MY3 FINAL MONITORING REPORT

Odell's House Mitigation Project

RE: WLS Responses to NCDEQ DMS Review Comments for Task 9 Submittal, Draft Monitoring Year 3 Report for the Odell's House Mitigation Project, DMS Full-Delivery Project ID #100041, Contract #7420, Neuse River Basin, Cataloging Unit 03020201, Johnston County, NC

FIGURE
1b

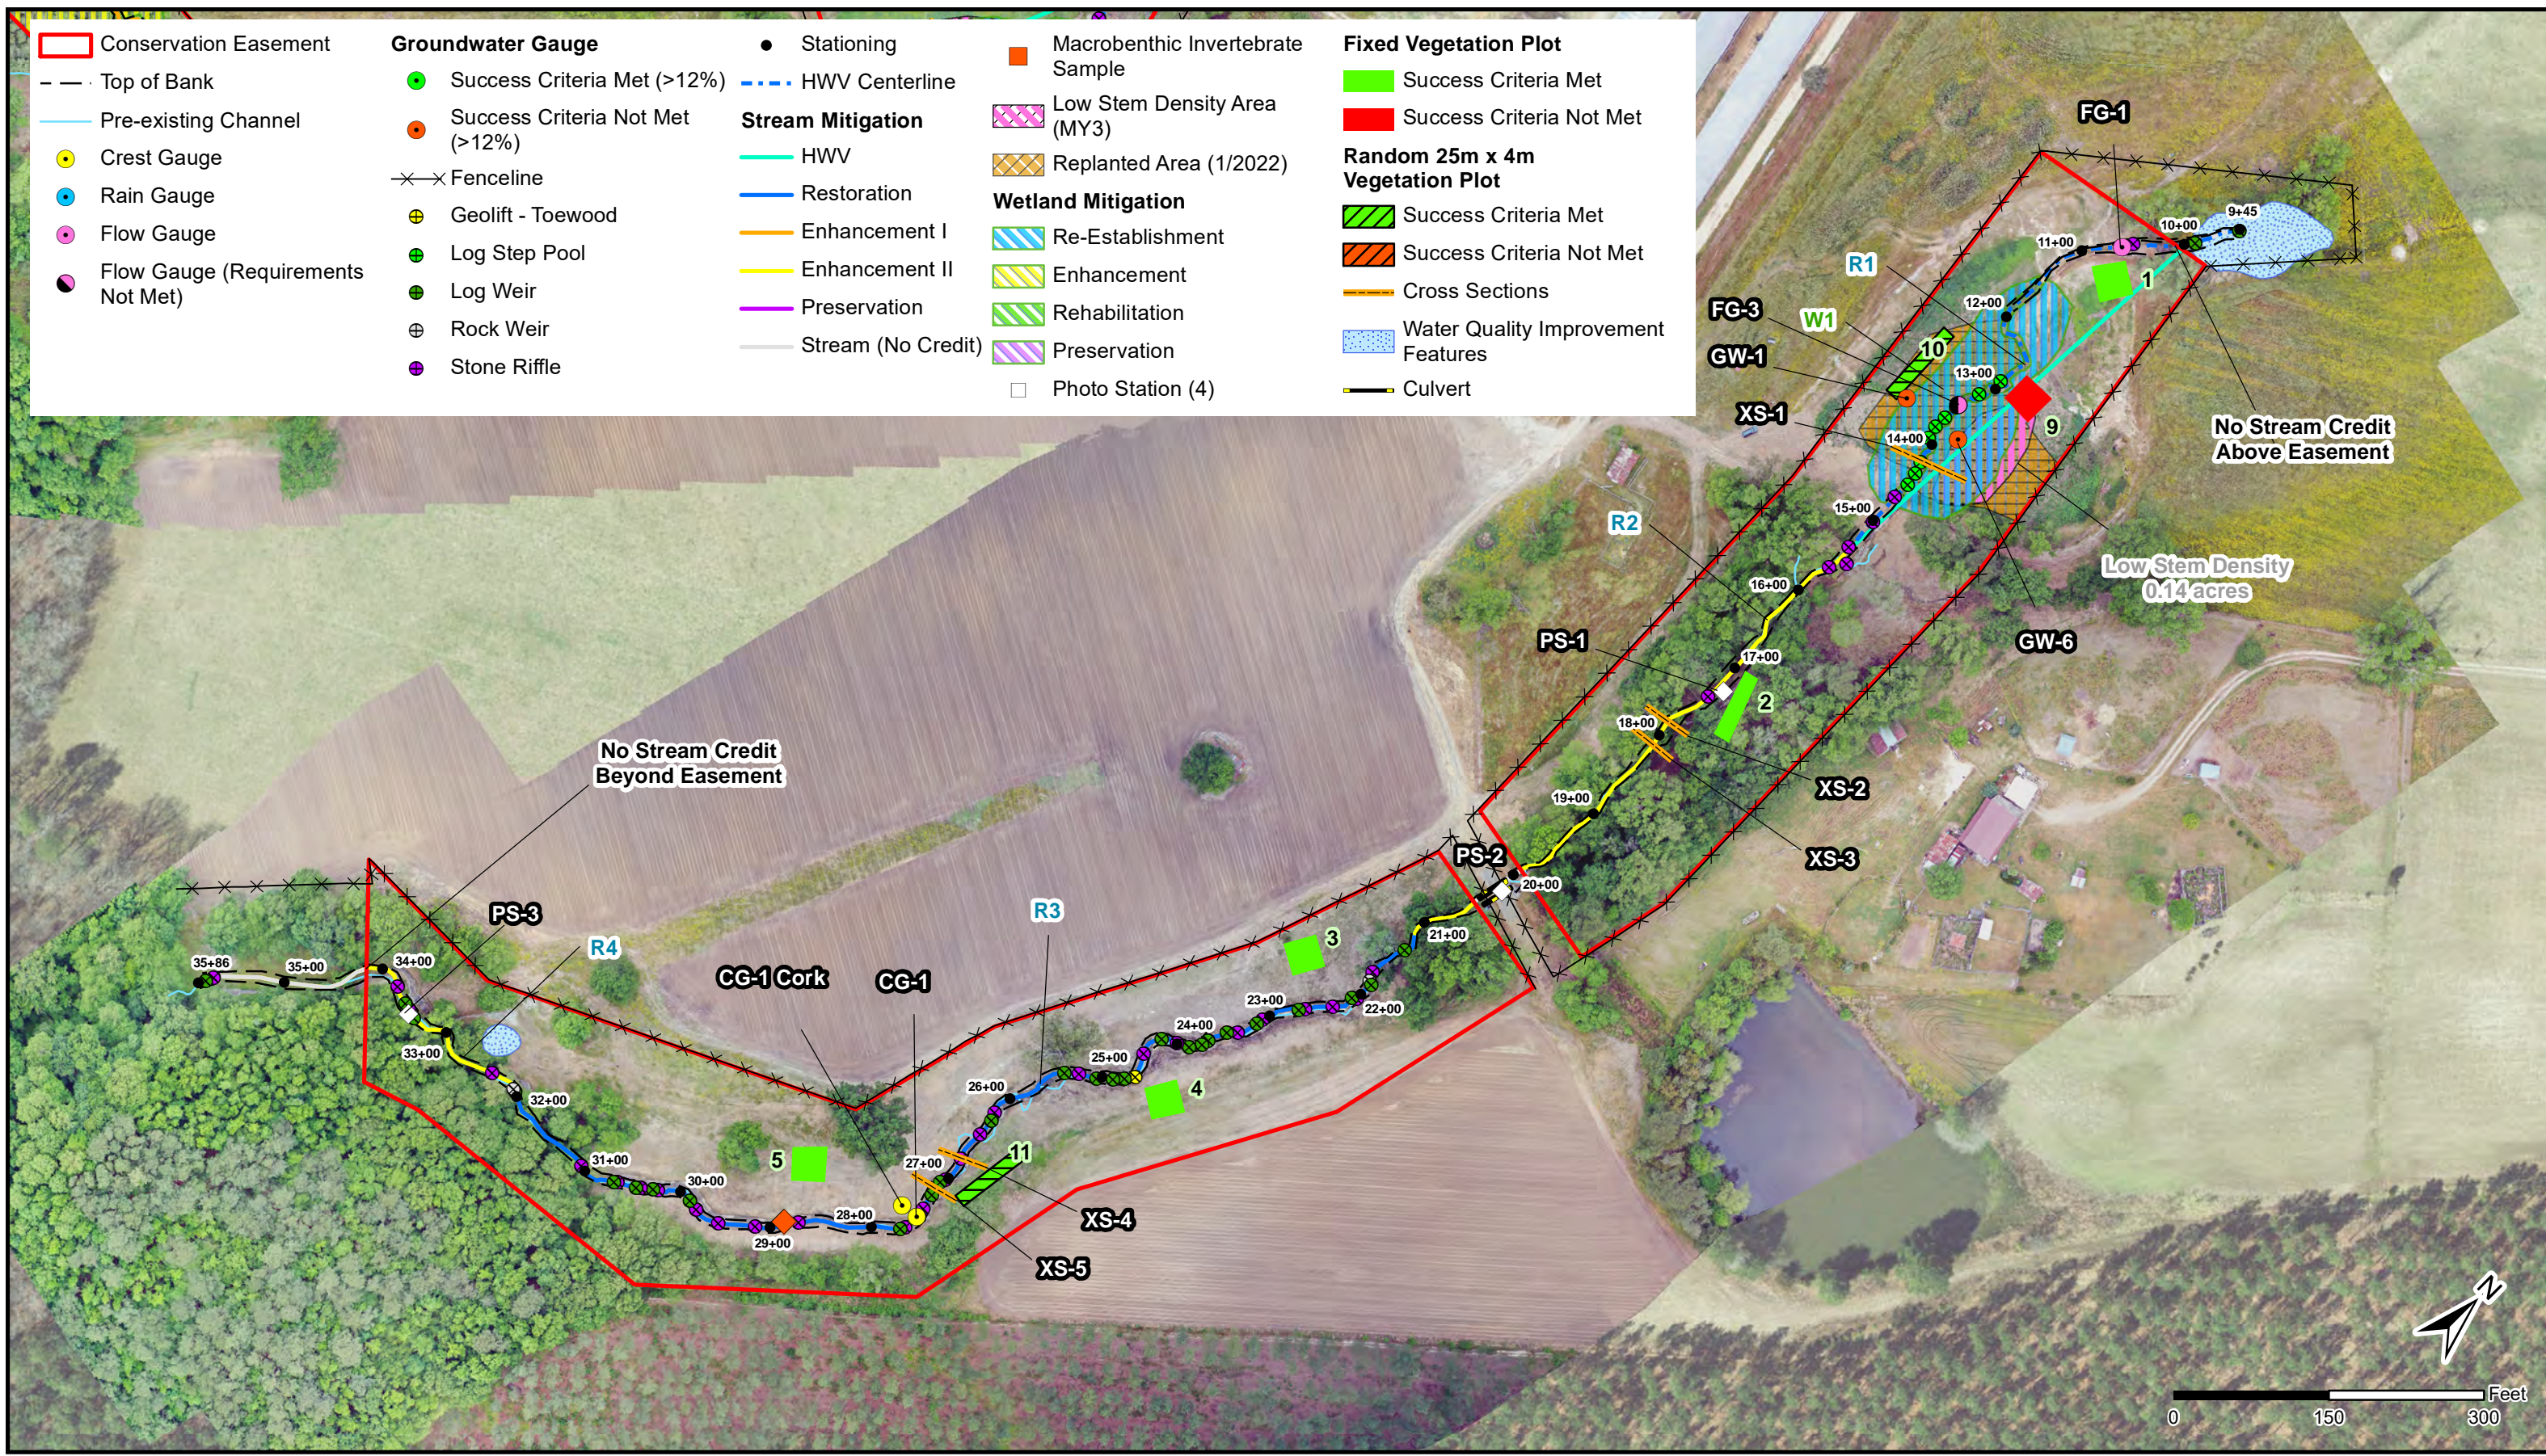
1. **Figure 1b: Add date to replanted area in legend (1/2022).** WLS Response: The date has been added to the replanted area in the Figure 1b legend.
2. **Figure 1b: Is the low stem density area the same as it was in MY2? Indicate if this is true by adding MY3 in legend.** WLS Response: The low stem density area is the same as it was in MY2 and the legend on Figure 1b and c have been updated accordingly.
3. **Appendix A, Vegetation Condition Assessment Table: Update low stem acreage to 0.33 acres.** WLS Response: The low stem acreage has been updated to the correct acreage in the Appendix A, Vegetation Condition Assessment Table.

Odell's House Mitigation Site Rainfall Data

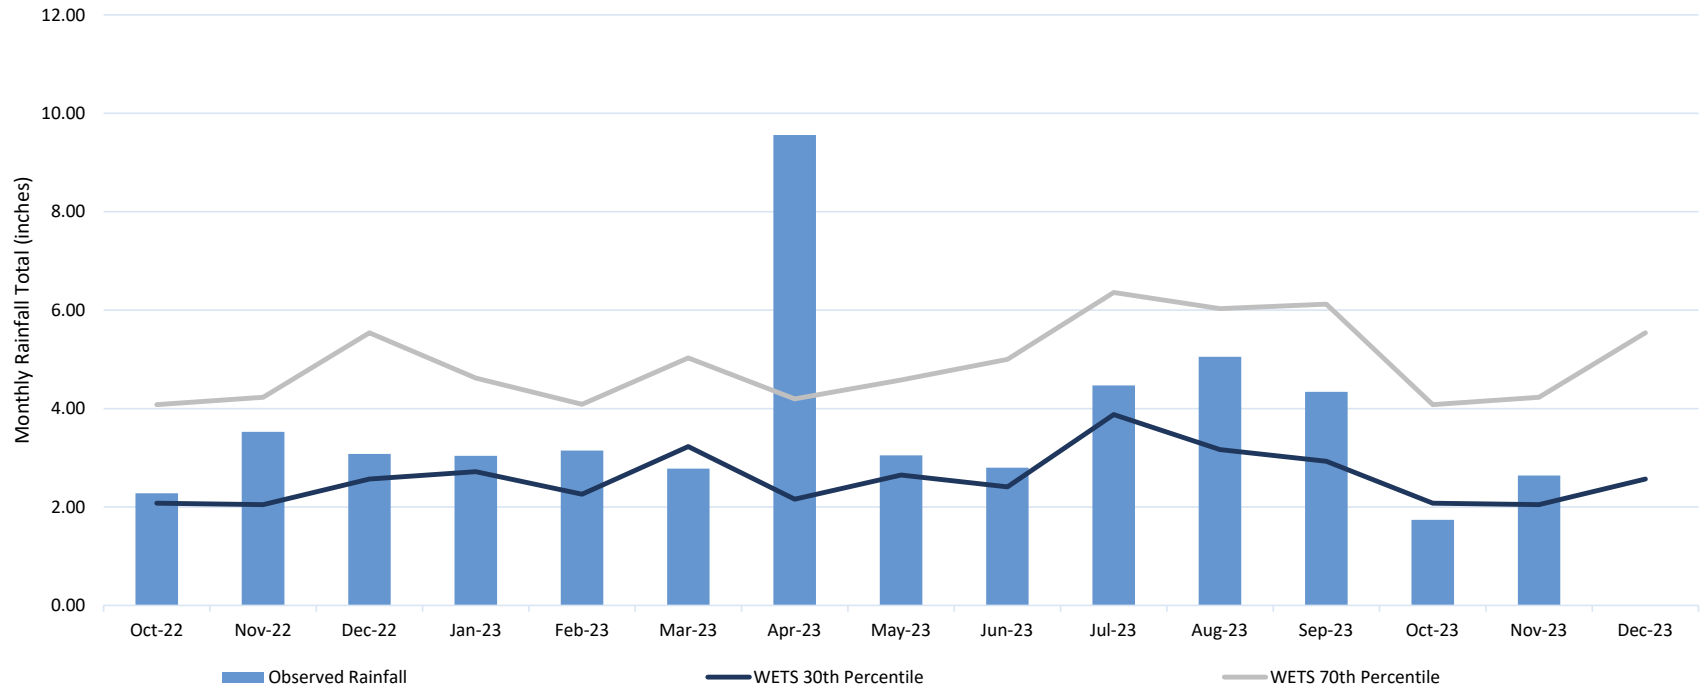
- 8. Appendix D, Rainfall Data Table: Based on the data for October 2023 rainfall was not normal; please update the table/graph. Please update with rainfall through November if possible.** WLS Response: WLS updated all months' rainfall overall designation and added the rainfall total for November 2023 in the table and graph.
